# EPRI Groundwater Assessment for TVA's Sequoyah Nuclear Plant

## Assessment Final Report

An assessment of radioactive groundwater contamination at Sequoyah Nuclear Plant (SQN) and the groundwater protection program at Sequoyah was performed March 26 through 30, 2007. This assessment was sponsored by the Electric Power Research Institute (EPRI) and was conducted to:

**Figure 1**

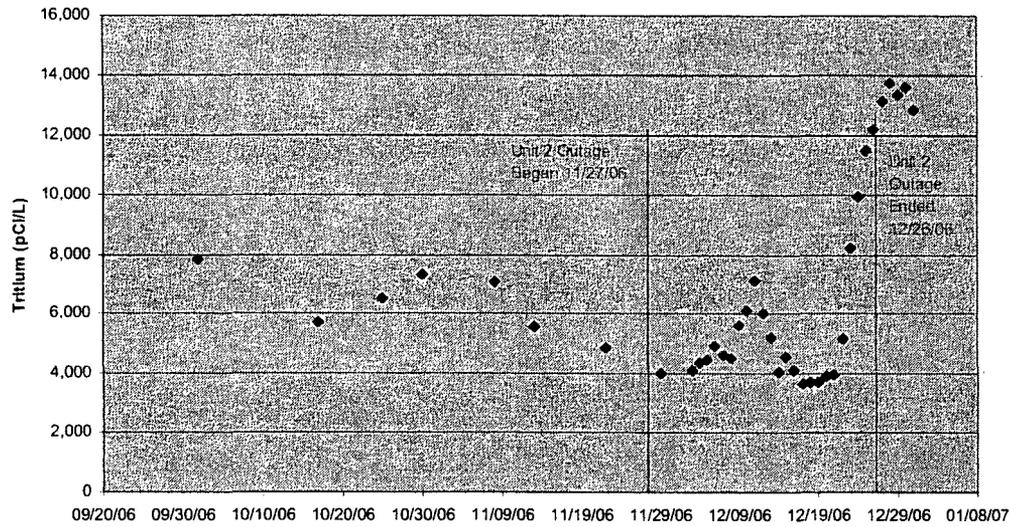
An evaluation of tritium concentrations and water levels in Well 31, and water levels in several nearby wells (Figure 1), shows a direct correlation between tritium concentrations in Well 31 and groundwater elevations. As groundwater levels in Well 31 rise and fall, so do tritium concentrations. Figure 1 shows that groundwater levels in Wells 31, 29 and 21 fluctuate up to approximately 7 feet on an annual cycle, with maximum and minimum levels occurring around July and January, respectively. These levels may correspond with the controlled flows in the Tennessee River (which also affect the water level in the cooling water discharge channel) and suggest a hydraulic connection of groundwater in these wells with flow in the river and/or the discharge channel.

Figure 1 shows that other wells west of the discharge channel (Wells 30, 32 and 33) have much smaller fluctuations in water levels, with little or no annual cycle apparent. This observation suggests that Wells 31, 29 and 21 may be hydraulically connected to the discharge channel by some natural stratigraphic feature or by some underground utility that provides a preferential flow path.

**Figure 2**

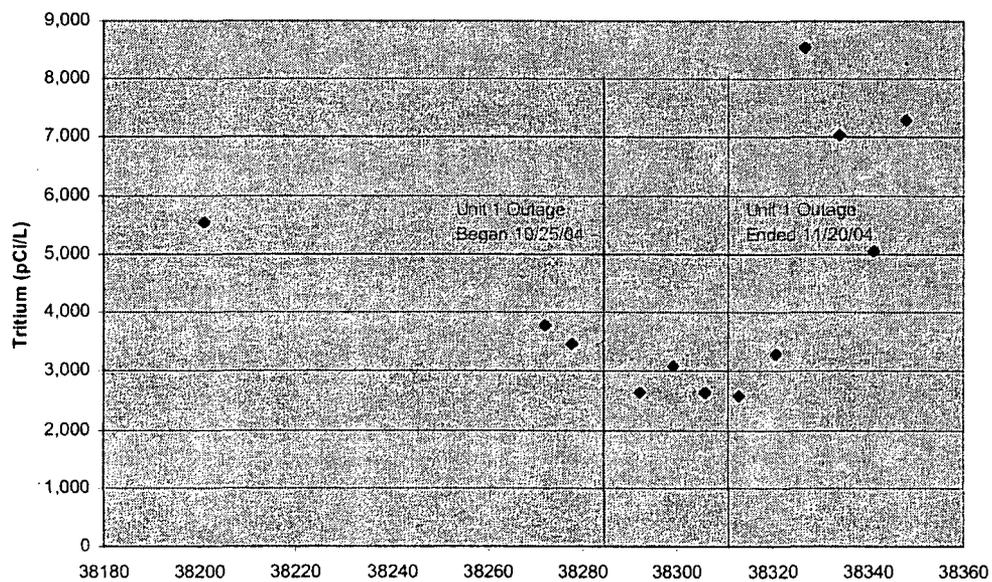
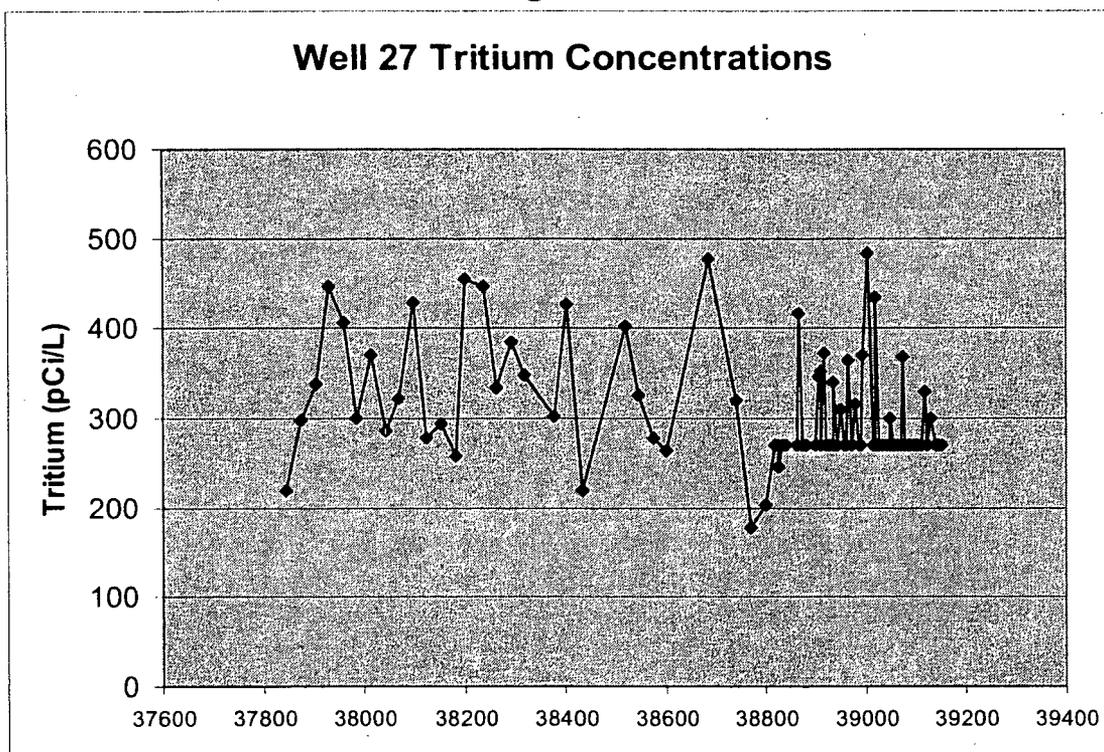
Figures 2 and 3 show the variation in tritium levels in Well 31 during the periods spanning the last two refueling outages in Unit 2 and Unit 1, respectively. These figures show that tritium concentrations in Well 31 are lowest during the outages and increase immediately following the outages. Because the flow of cooling water is reduced during outages, it is likely that the water level in the discharge channel is lower during outages. Lower tritium levels in Well 31 during outages support the conceptual model of rising groundwater remobilizing tritium from historical surface spills that is suspended in the vadose zone.

The EPRI assessment team recommends that the shallow soil in the vicinity of the historical surface spills noted above be sampled and analyzed for tritium. If significant concentrations of tritium are detected in the shallow soils, it would be reasonable to conclude that the historical surface spills are the source of the tritium measured in Wells 31, 29 and 21, rather than an ongoing leak in an active structure, system, or component (SSC). Confirmation of the presence of tritium in the soil would not dictate that it be removed immediately, but may provide an explanation for the observed distribution of tritium in groundwater.
